**CERTIFICATE OF APPROVAL PACKAGE -  
REQUEST FOR APPROVAL MEETING**

206 5th Ave S

#6653595 - CN

ORIGINS 206

PROPOSED DESIGN | EAST ELEVATION (ALLEY)

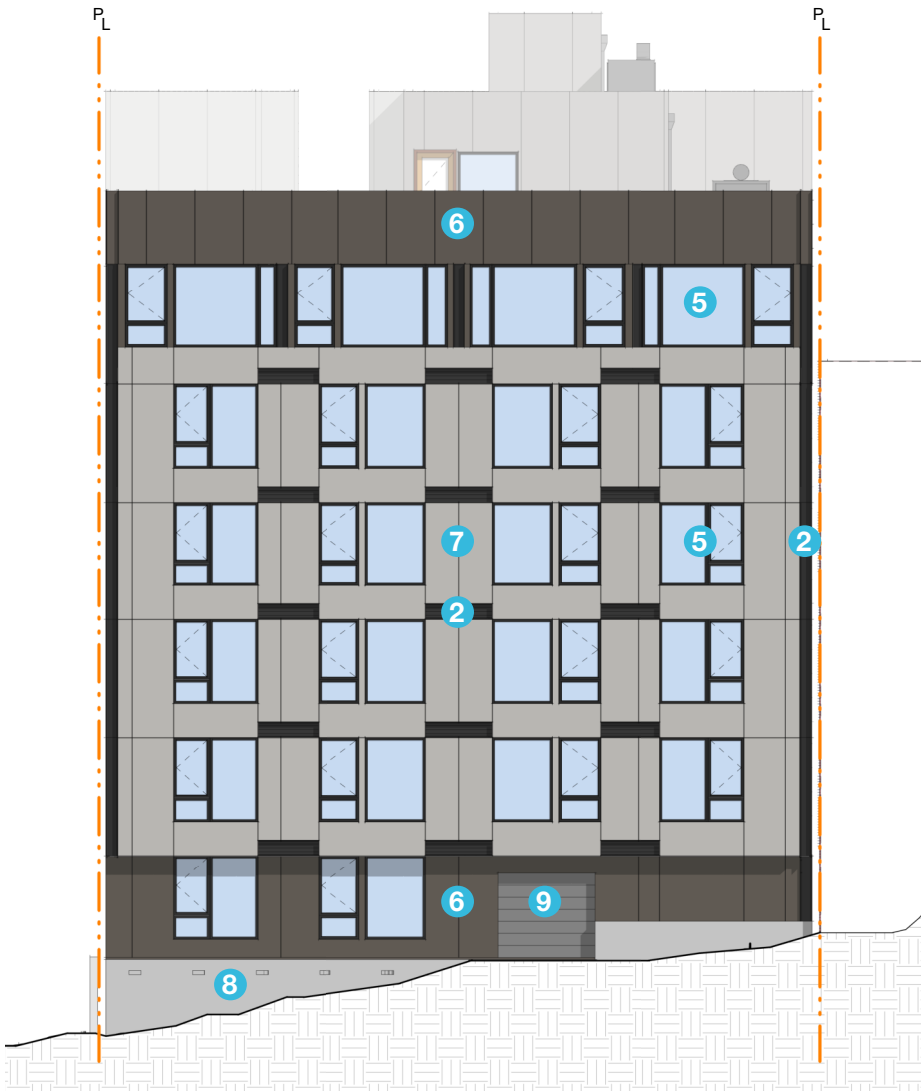
After seeking public feedback, no concerns were raised about the cultural impact of a high contrast facade. However, several attendees noted that they preferred a medium contrast facade.

The proposal has been refined, now showing the main mass as cool light gray that softens the contrast but still achieves the goal of reflecting light into the alley.

WALL SECTION

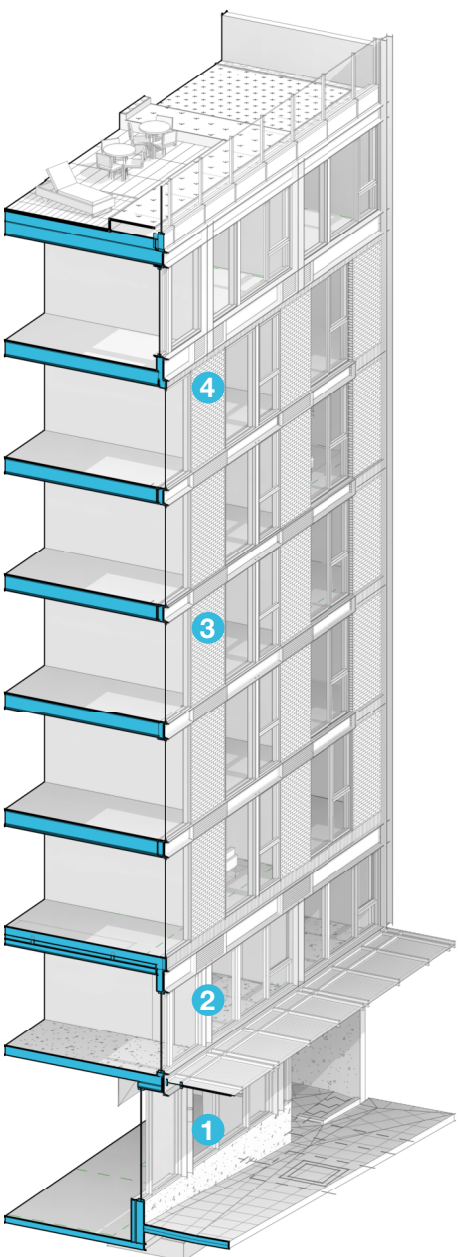
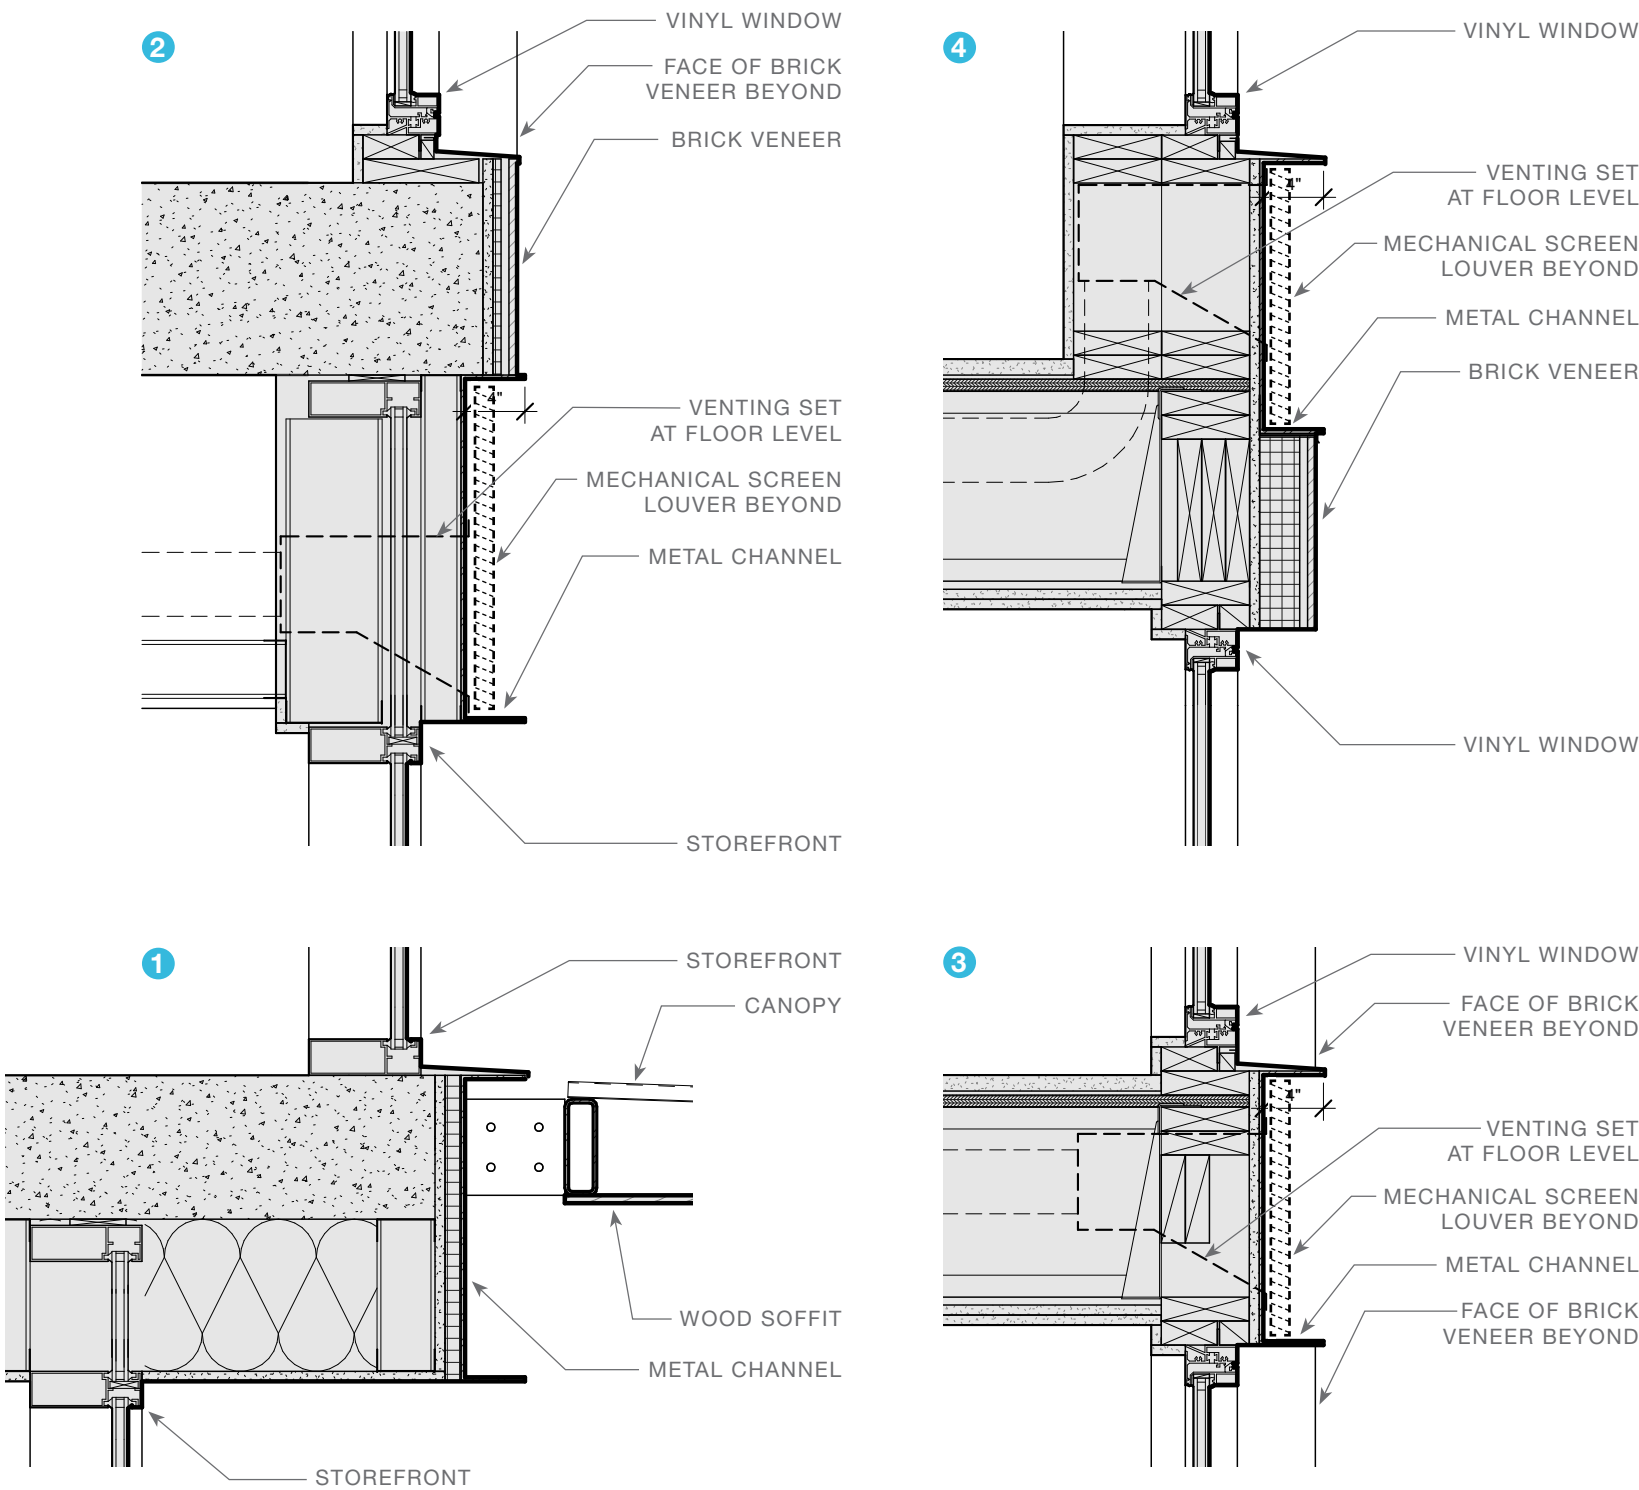
The Board requested that the team provide additional details showing how the edge of the canopy soffit panels will be treated.

The design team presented a full height axonometric section, studying the key details at material transitions, glazing and venting locations. In addition, CD details were reviewed for the canopies and physical material samples were reviewed for all proposed materials and colors.

PROPOSED DESIGN | STREET LEVEL LIGHTING PLAN

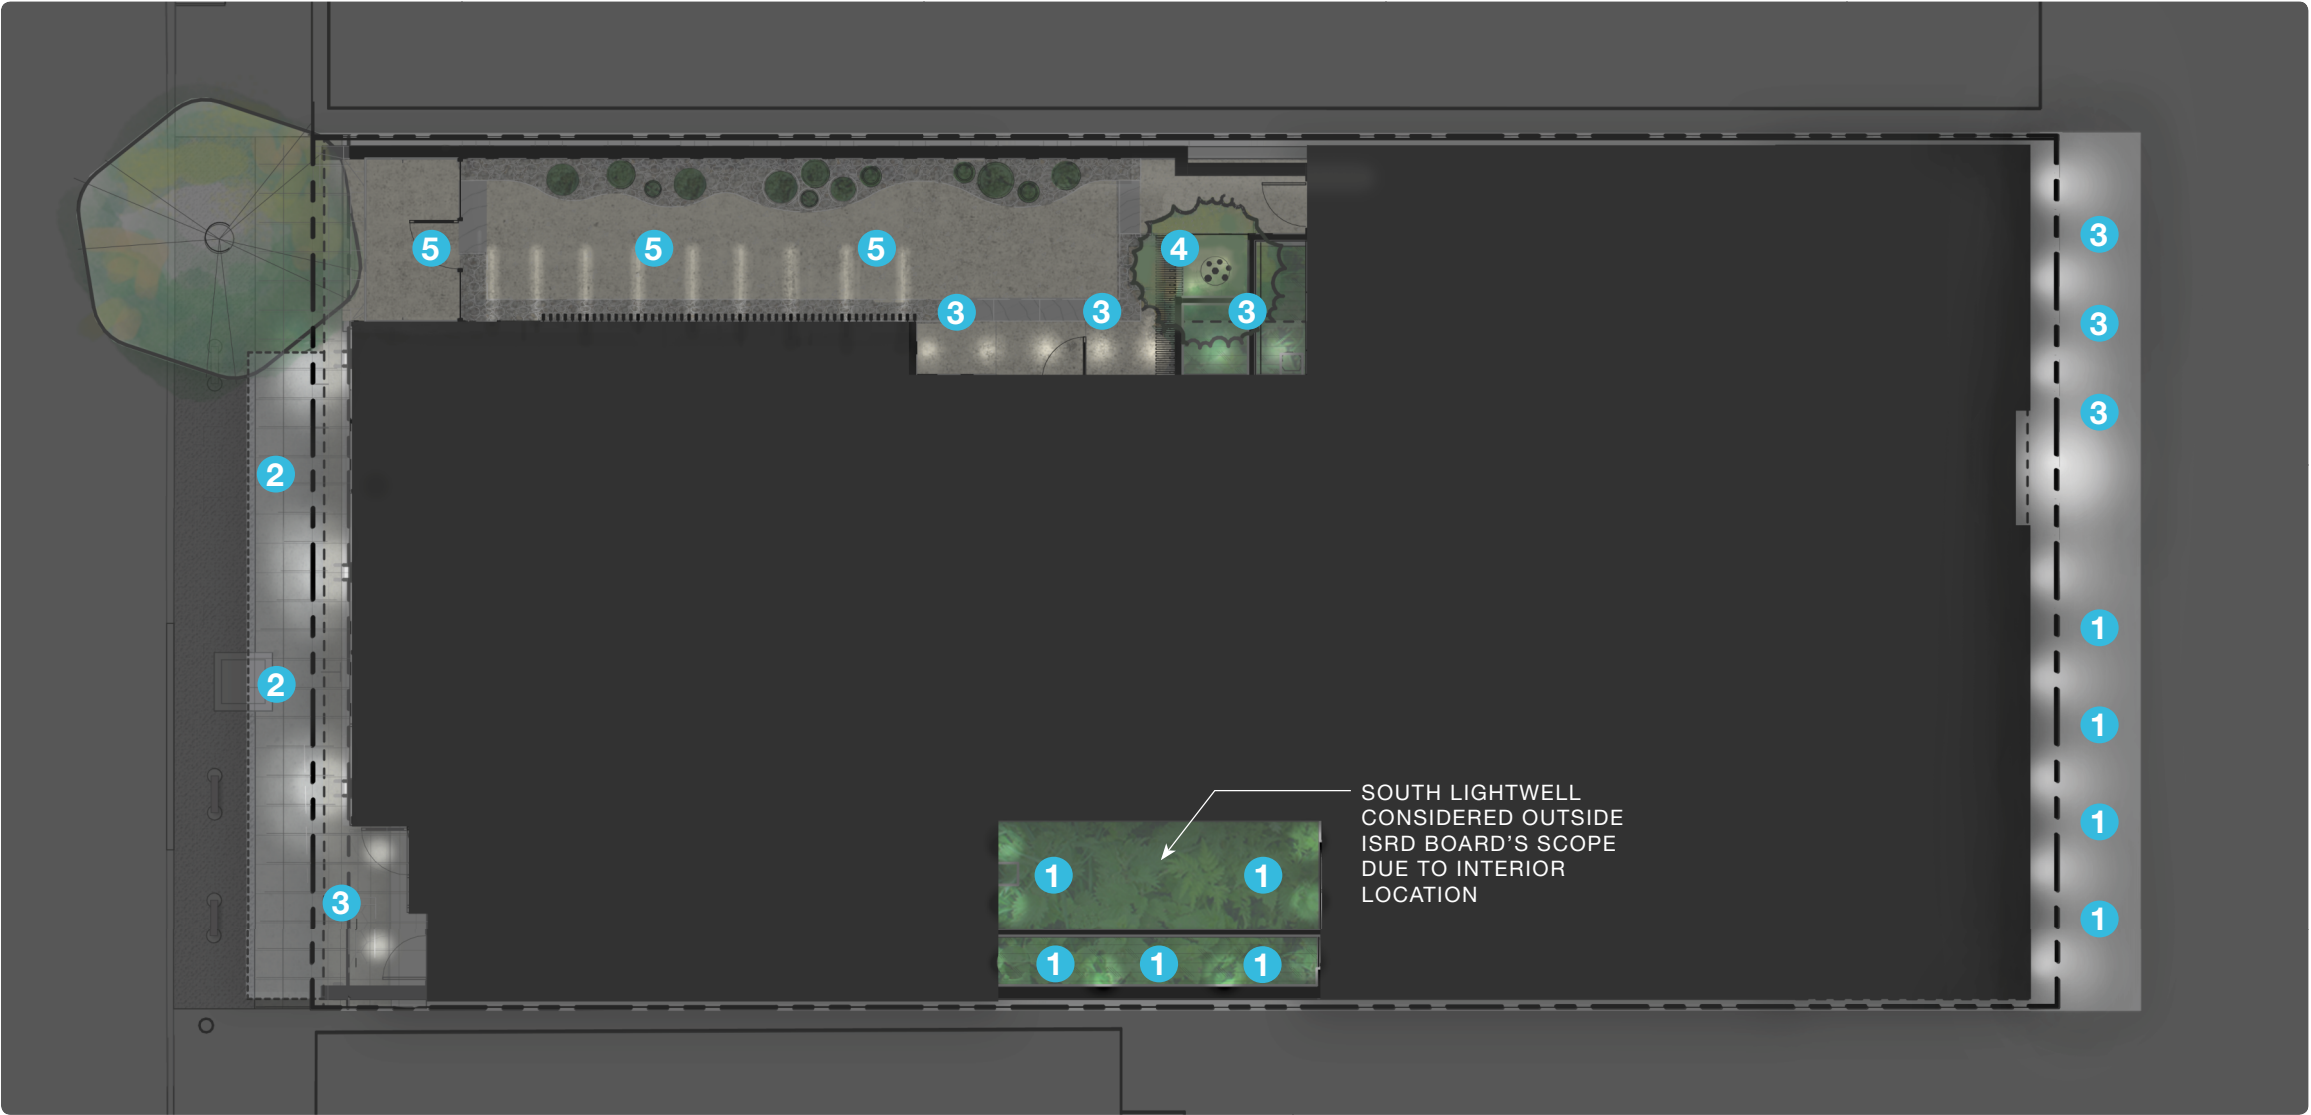
As requested by the Board, the update lighting plan shows proposed alley lighting, in addition to the previously noted lighting.

- Alley lighting is achieved with a combination of recessed step lights and downlights for minimal tenant impact and maximum alley security.
